STAFF RECOMMENDATION 1624 Gartland Avenue December 20, 2017

Application: New construction—outbuilding/detached accessory dwelling unit
District: Lockeland Springs-East End Neighborhood Conservation Zoning Overlay
Council District: 06
Map and Parcel Number: 083100162
Applicant: Craig Kennedy, Bootstrap
Project Lead: Jenny Warren, jenny.warren@nashville.gov

Description of Project: Application is for the construction of a new detached accessory dwelling unit.

FLOOR PLANS
H1.0

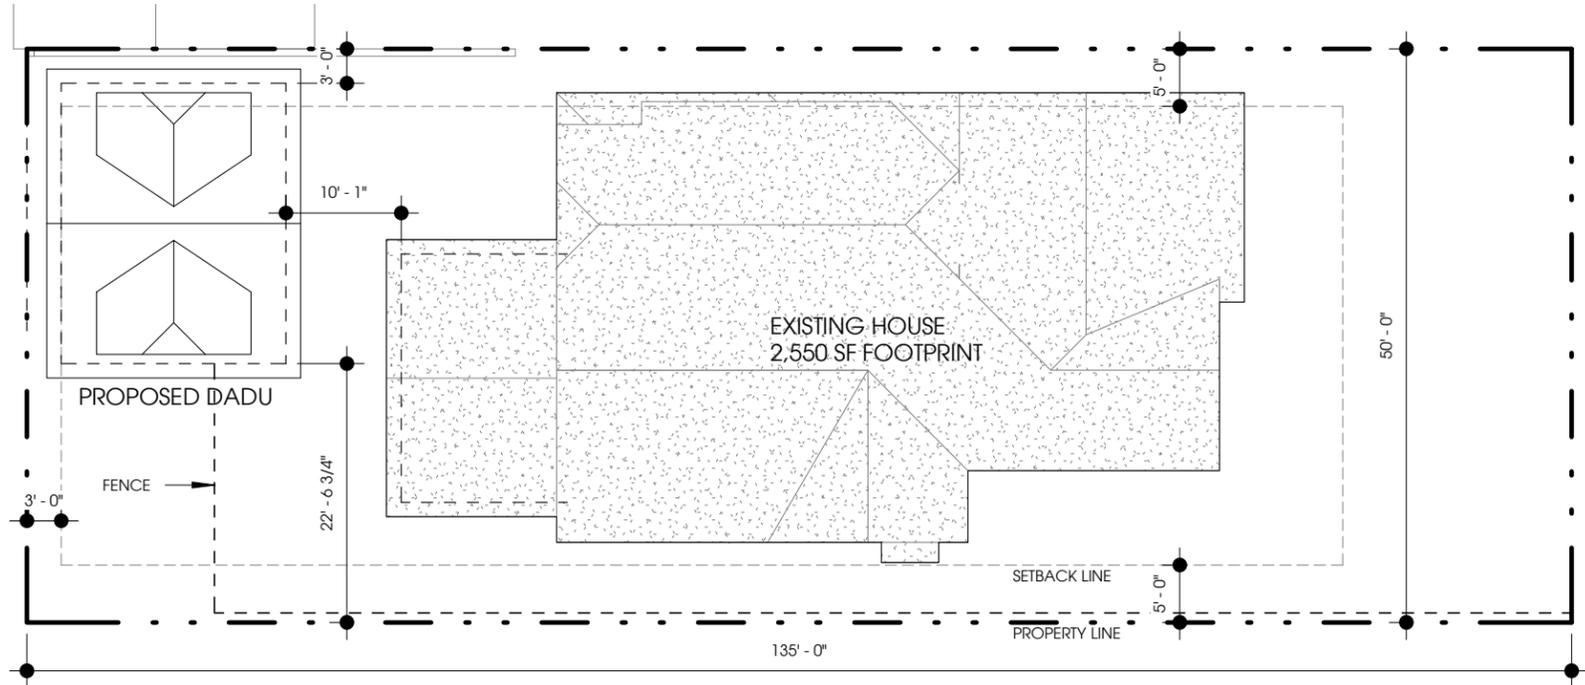
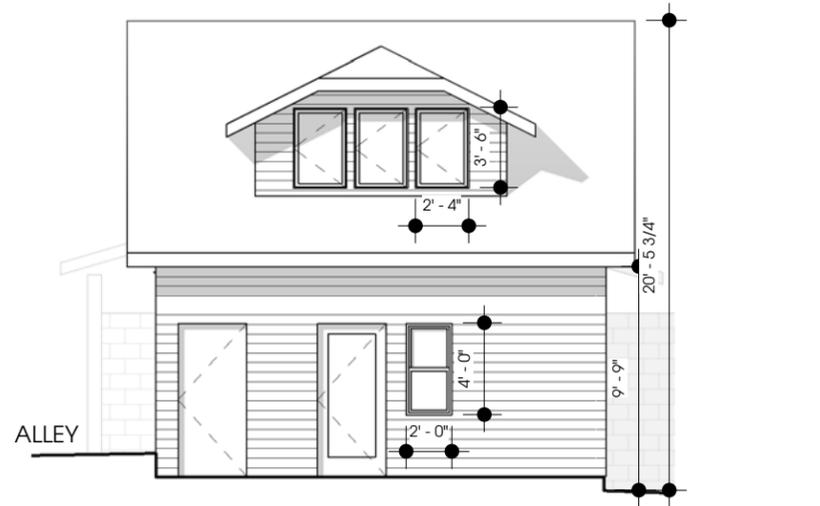
Outbuilding description:	Proposed	Minimum Rear/Alley Setback	Minimum Side Setback for interior lot lines	Minimum Side Setback, Side Street for corner lots	Distance Between Principal Building and Outbuilding
Footprint less than 700 sq. ft., Garage doors do not face alley	481sq ft (no garage doors)	3'	3'	10'	20'

The existing outbuilding sits on the side and rear property lines. The new outbuilding must comply with the required setbacks. The proposed design is inset three feet (3') from the property line along the alley and three feet (3') from the adjacent property. The building will be setback more than twenty-two feet (22') from N 17th Street. Due to the small size of the lot, the DADU cannot be located a full twenty feet (20') from the rear of the main house. This lot is only one-hundred and thirty-five feet (135') deep. The applicant proposes a ten foot, one inch (10' 1") separation between the rear wall of the house and the side wall of the outbuilding. Staff finds that given the narrow depth of the lot, and the need to now comply with the rear setback, this distance is appropriate. The Commission has approved separations of ten feet (10') in the past in instances with similar site restraints.

Proposed	50% of first floor area of principle structure	Lot is less than 10,000 square feet	Proposed
Maximum Square Footage	1,275sq. ft.	750 sq. ft. (including porches)	481 sq. ft.

The project meets section II.B.8 of the design guidelines and 17.16.30.G. 4 of the ordinance.

ELEVATIONS

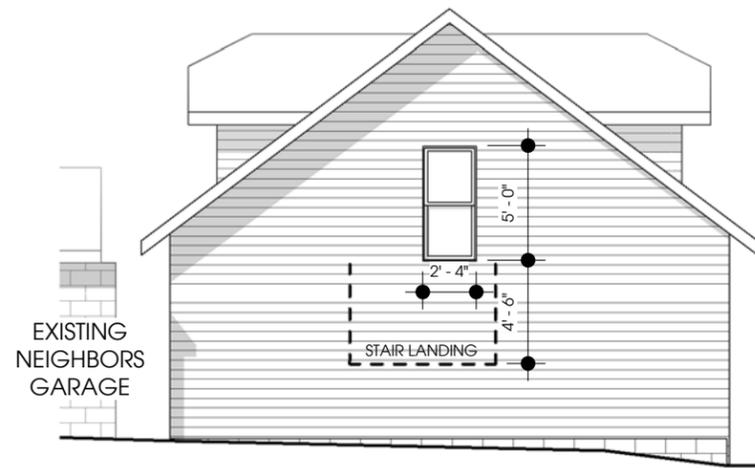
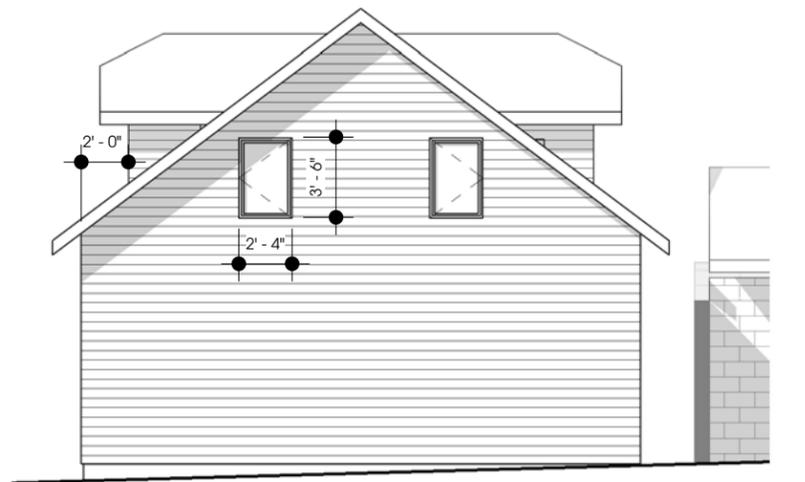
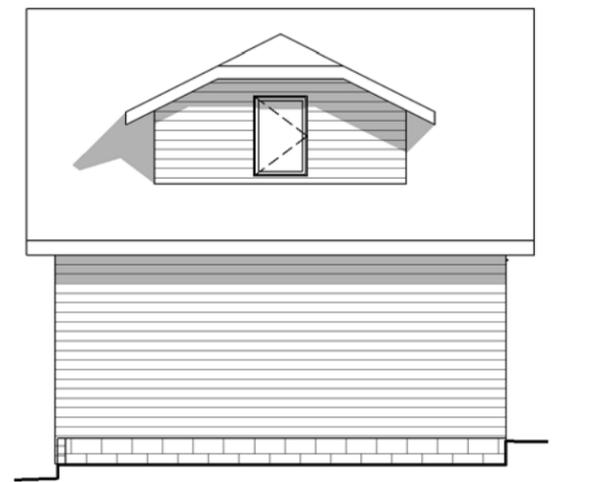
Proposed Element	Proposed Form	Typical of district?
Primary form	Side-gable	X
Primary roof slope	9/12	X

The accessory structure has a simple, utilitarian design that is appropriate for outbuildings. Its roof form, detailing, and form do not contrast greatly with the primary structure. The fenestration is simple and does not contrast greatly with the neighborhood context.

Proposed	Color/Texture	Approved Previously or Typical of Neighborhood
Foundation	Split face CMU	Natural color	X
Cladding	Cement-fiber	Smooth with 5” reveal	X
Roofing	Asphalt shingle	Match existing house	X
Trim	Cement fiber	smooth	X
Windows	Wood clad or fiberglass	Needs final approval	X
Doors	Not indicated	Needs final approval

Potential maximums (heights to be measured from grade)	Existing conditions (height of historic portion of the home to be measured from finished floor)	Proposed
Ridge Height	25' unless existing building is less	24'	~20' 6"
Eave Height	1 story 10' unless existing building is less	10' average	9'9"

With the Staff’s final approval of the windows and doors, Staff finds that the known materials meet Section II.B.8.a.

1. Staff receive a copy of the filed restrictive covenant for the detached accessory dwelling unit prior to issuance of a permit.
2. Staff approve the doors and windows prior to purchase and installation.
